KMR.CDD.MIQ.1932-1933.01 B

With reference to your application dated...15-5-33...193
with a plan for the proposed building additions and alterations on plot
No. 147, 148 Survey Sheet No. M.R.1. Market Quarter
I have to request you to comply with the following requirements:—

PLAN OF PROPOSED ADDITIONS & ALTERATIONS
ON PLOT NO. 147 & 148. M-R-1.

Re. Plot no. 147 & 148, M.R. 1, Market Qtr.

SECTION OF EXISTING BALCONY
ON BUNDER ROAD.
SCALE 8-1.

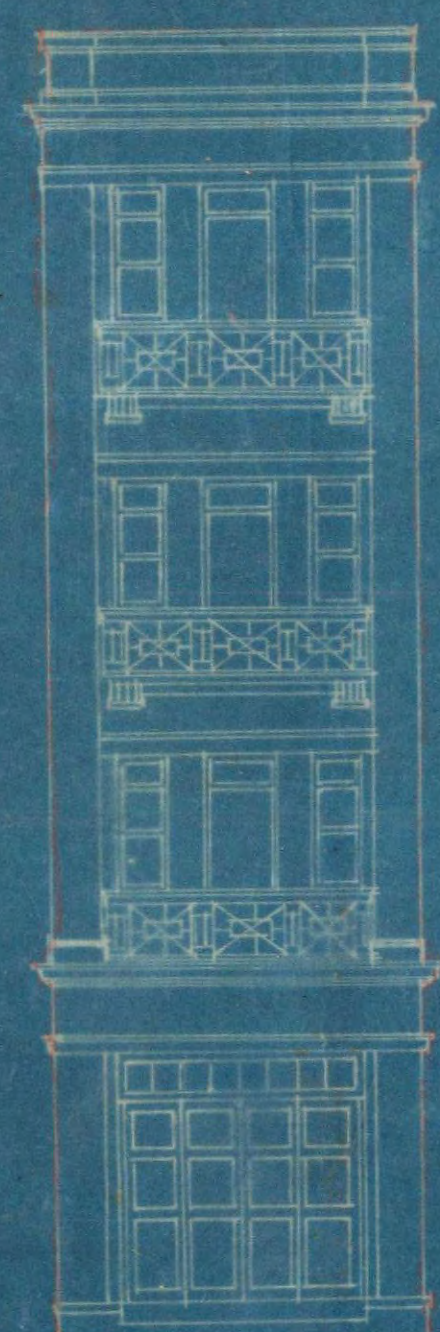
- 1) Rights of party wall be produced & the existing owner's signature be required in the plan.
- 2) R.C. beams ^{carrying passages & Samsan block} with their dimensions & reinforcement be specified.
- 3) We in the ground floor behind stairs is against the wall.
- 4) Stairs be made fire proof.
- 5) Existing balcony will have to be jointly measured & its measurement & position settled. It will be allowed in its present position & of the same dimensions. ^{A photo be taken} 5 photos plan be prepared.
- 6) Kitchen behind stairs are dark.
- 7) Section line be fully shown.
- 8) The dimensions of the existing balcony as shown in section separated are not correct.

1. Premises may be kept open for inspection and
you should be present on the site on 28-8-33
~~between 8-30 AM~~ at 8 AM so that joint measurement be taken
of the balconies before the building plans can be
considered.

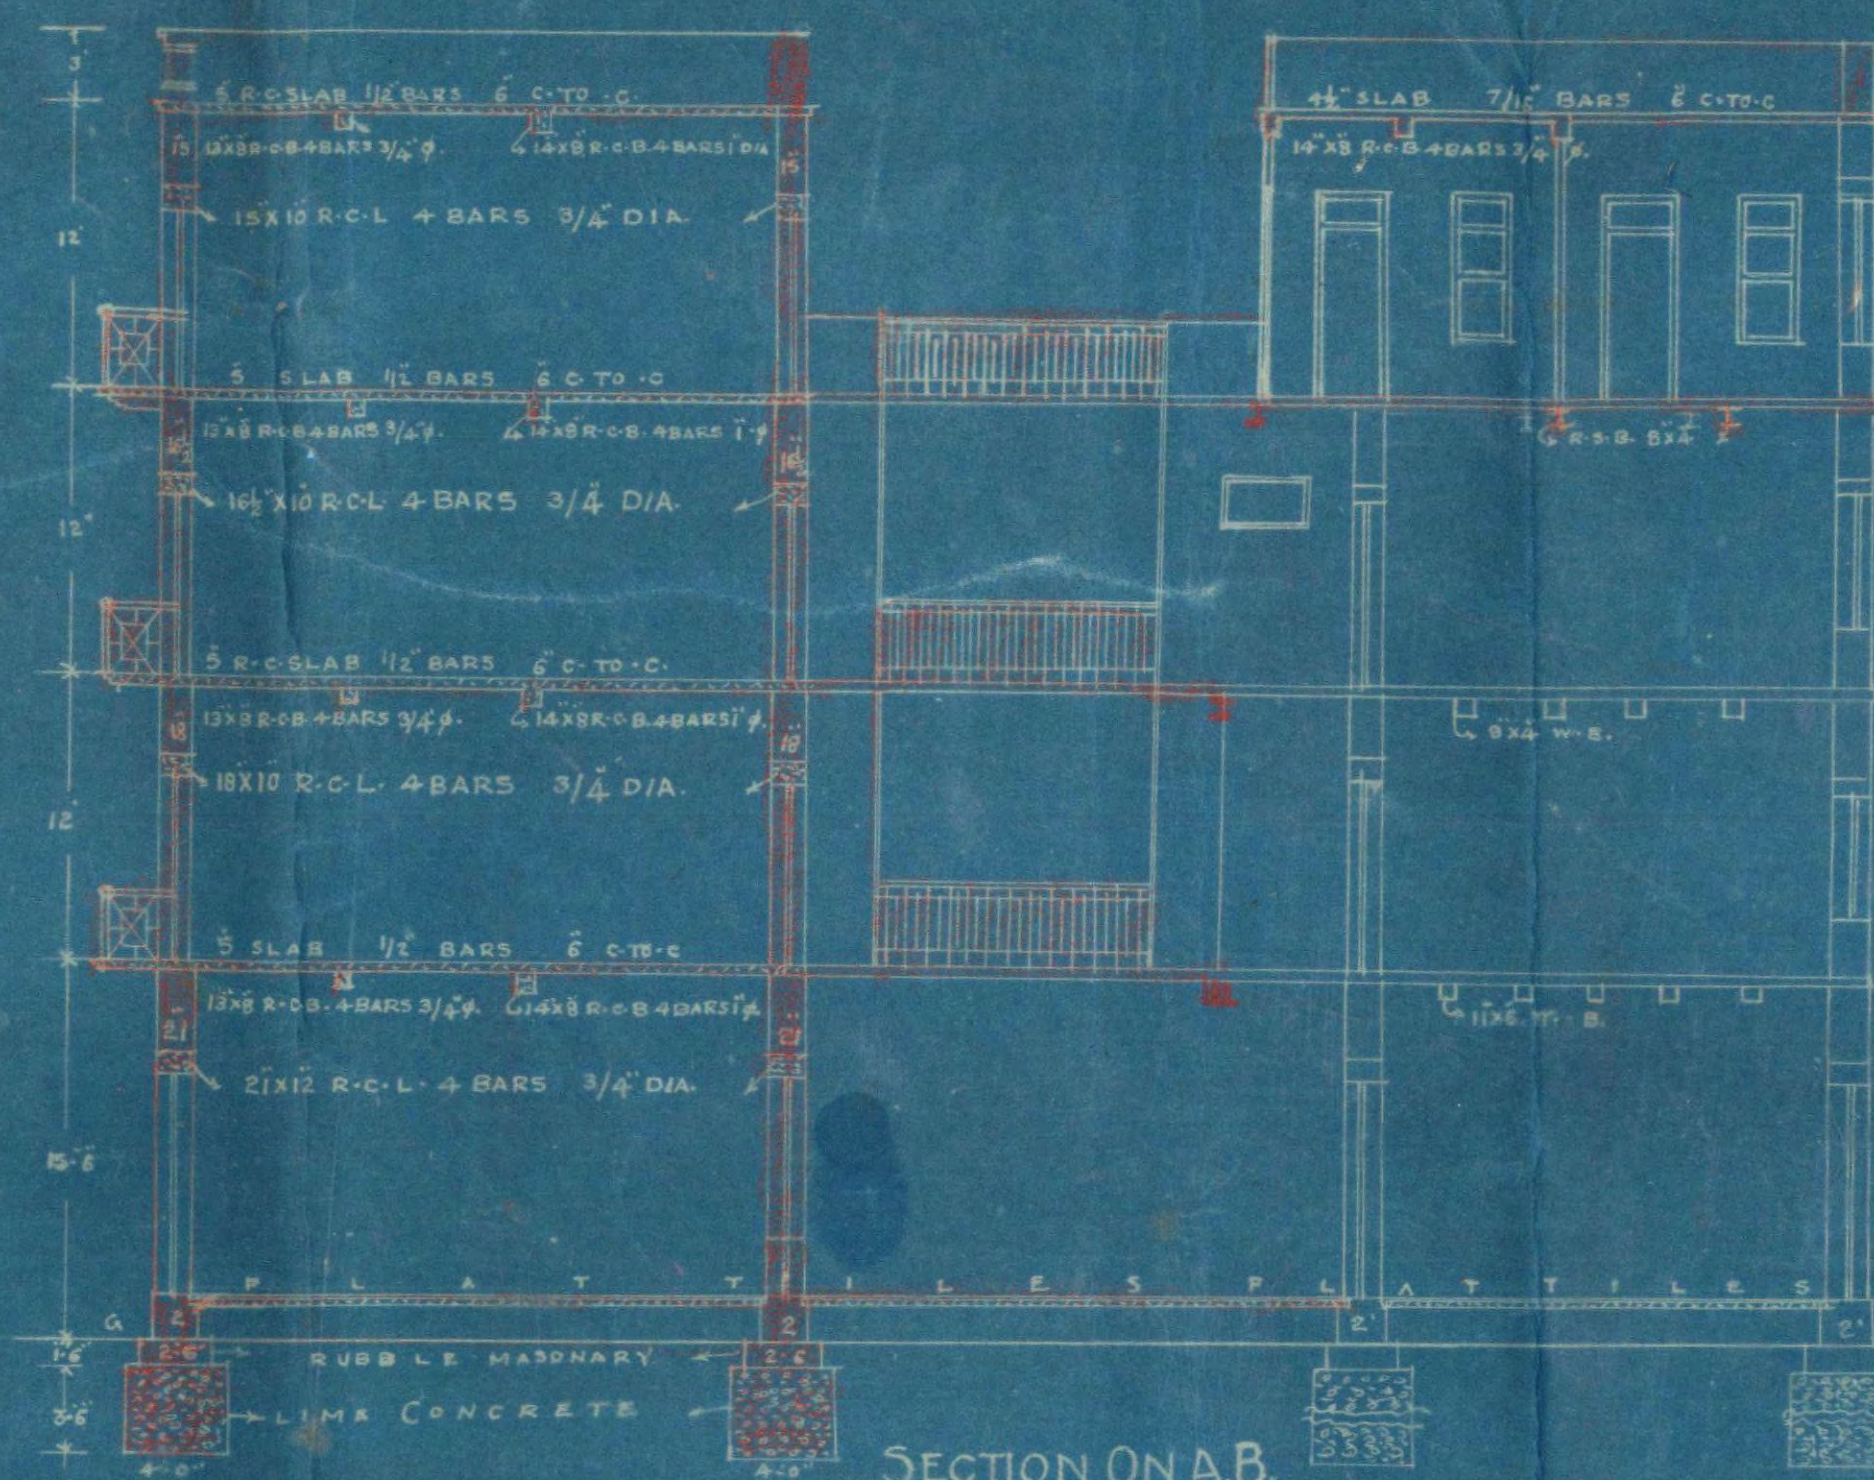
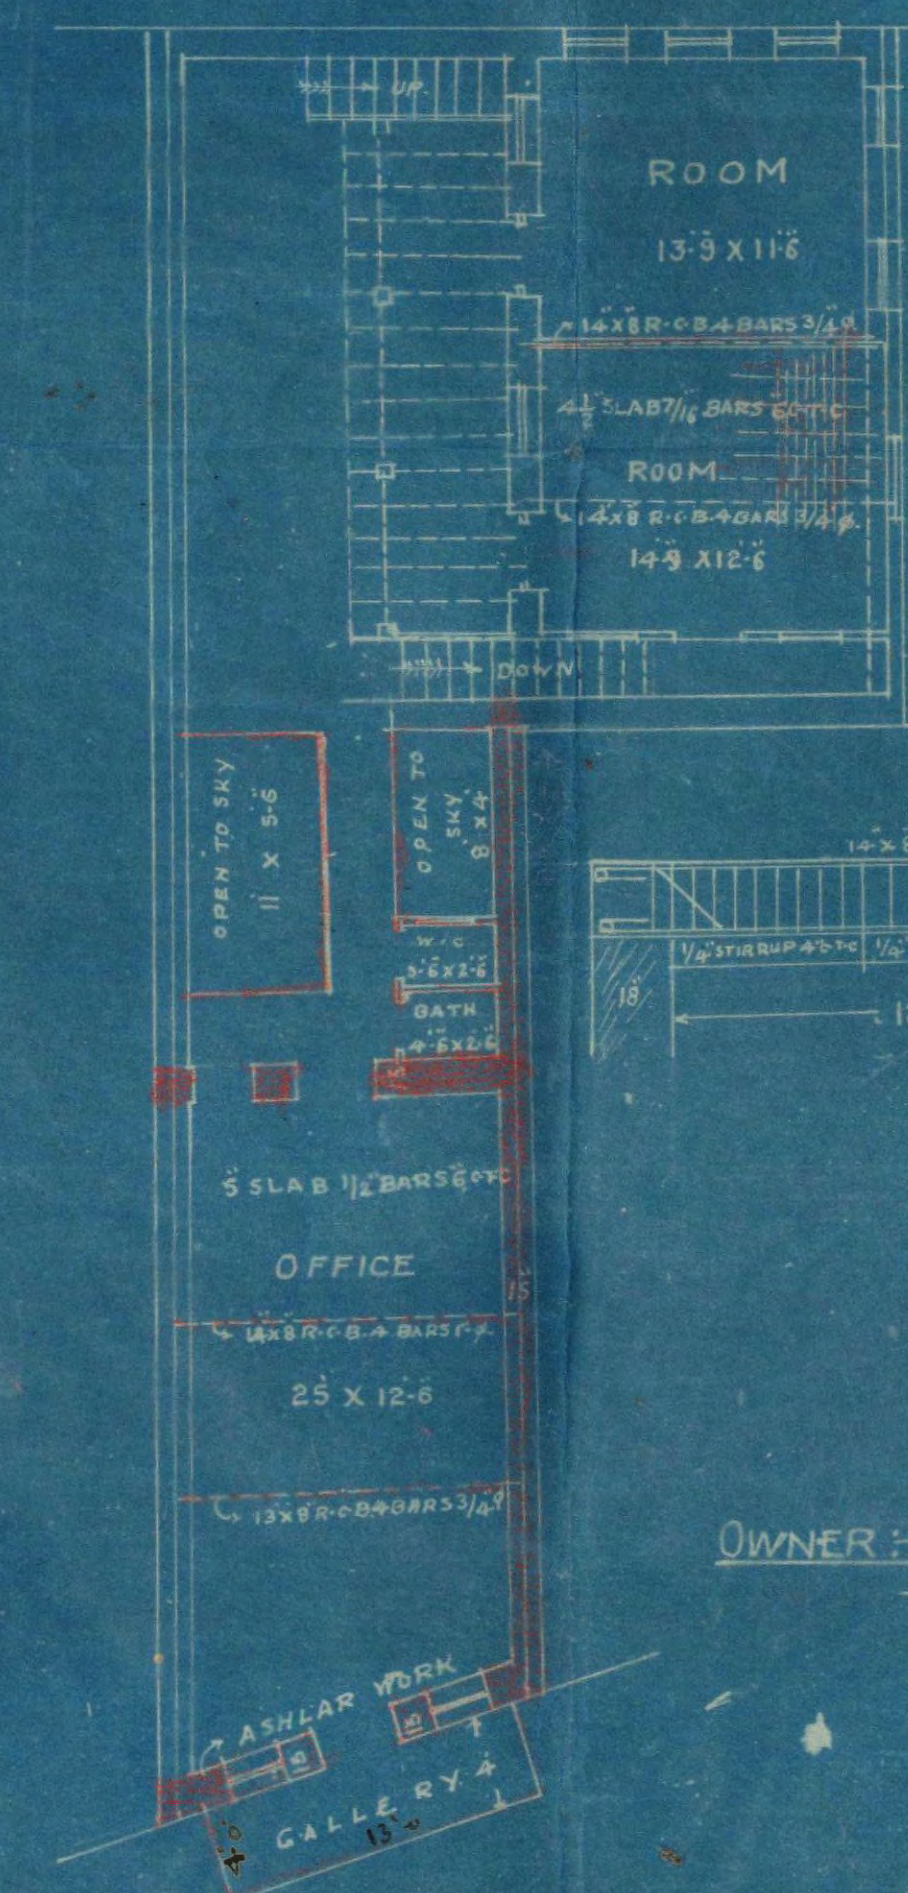
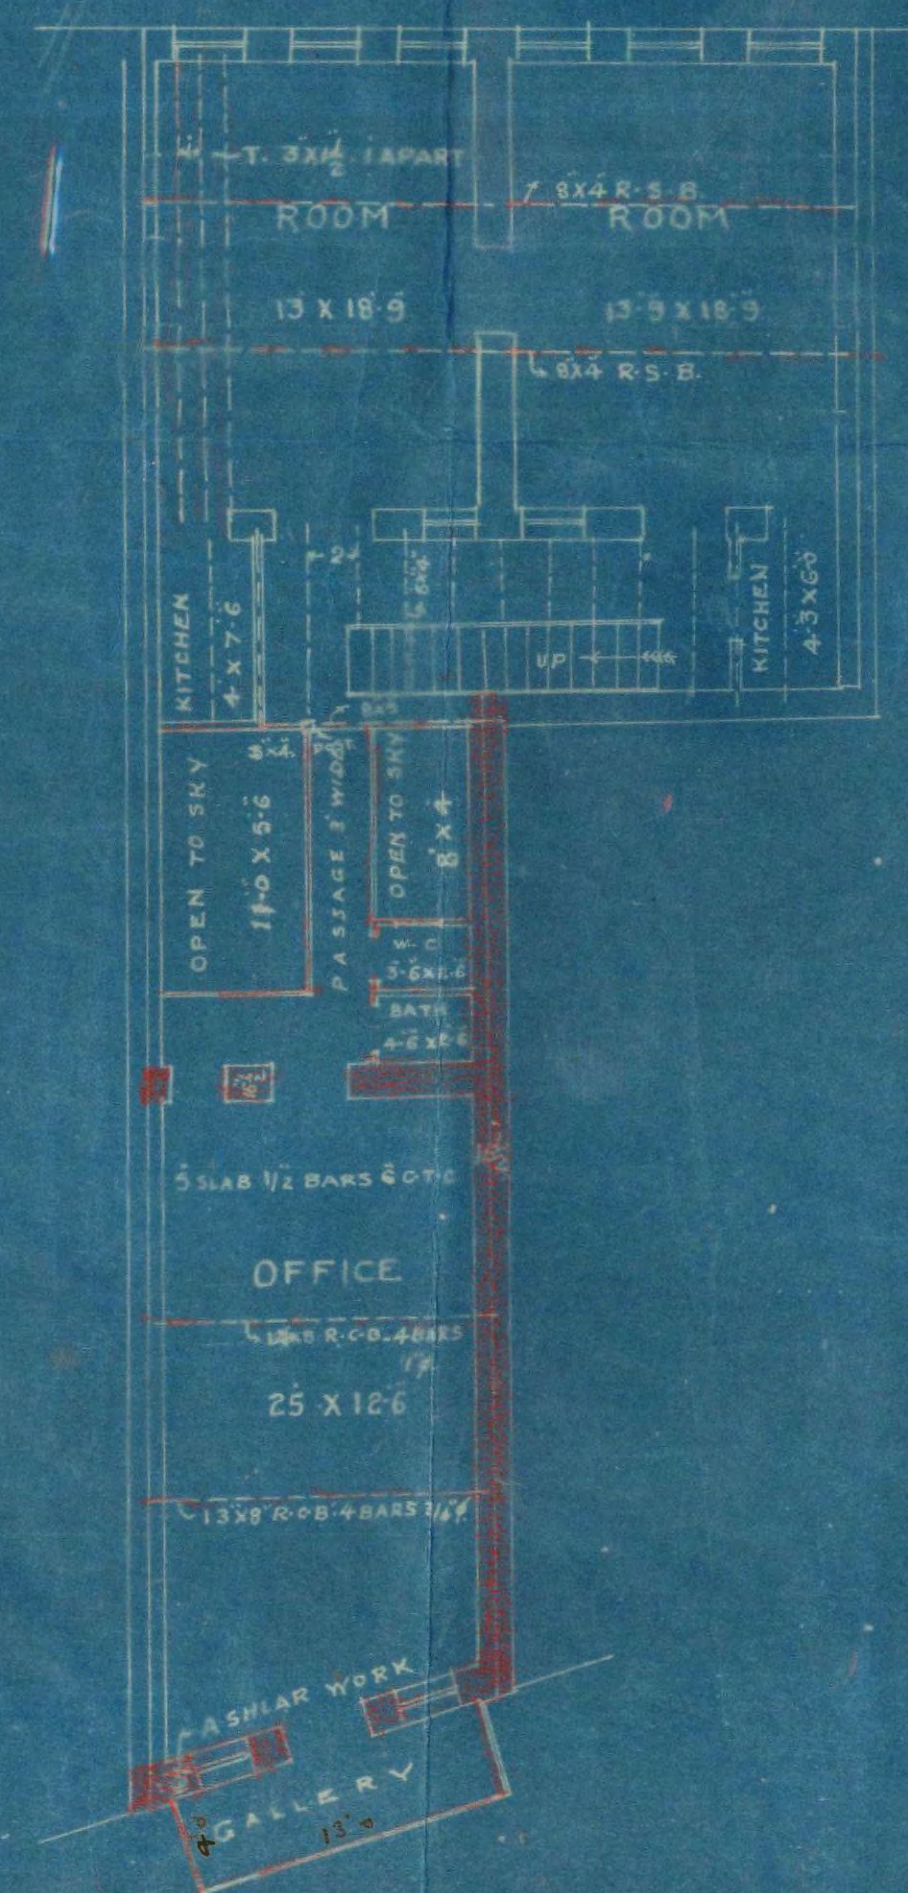
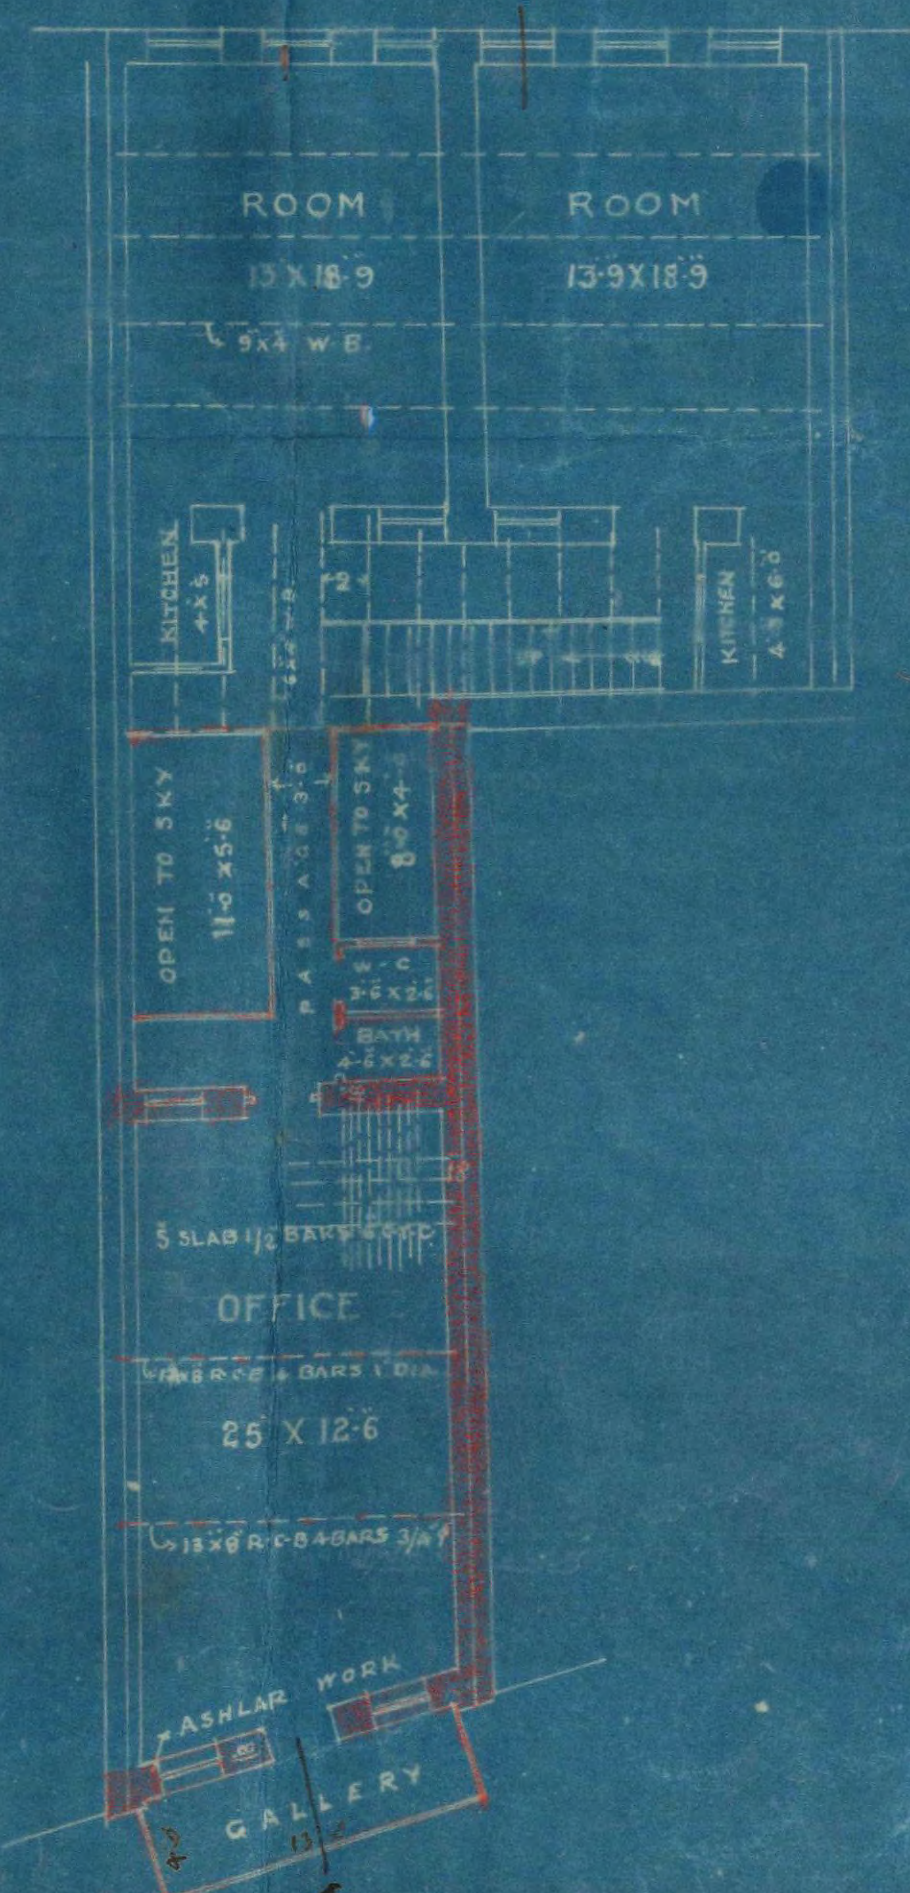
- 1) width of road be given
- 2) measurements must be corrected
- 3) Plots must be amalgamated

1. Right of party wall be produced and the adjoining owner's signature is required on the plan.
2. R.C.C. beams carrying passages and sanitary block with their dimensions and reinforcement be specified.
3. W.C. on the ground floor with stairs is against the rules.
4. Stairs be made fire proof.
5. Existing balcony will have to be jointly measured and all measurements and position settled. It will be allowed on its present position and of the same dimensions. A photo thereof be taken.
6. Kitchen behind stairs are dark.
7. Section line be fully shown.
8. The dimensions of the existing balcony as shown in section separately are not correct.
9. Width of roads be given.
10. Measurements must be corrected.
11. Plots must be amalgamated.
12. Front pillars must be 3' in widths.

1. Objections 1 to 5, 9, 10 & 12 are complied with.
2. As regards no. 6, the kitchens are in the existing portion and not proposed new.
3. As regards no. 8, this will be settled personally.
4. As regards no. 11, the plots ~~already~~ are one and no amalgamation is necessary.
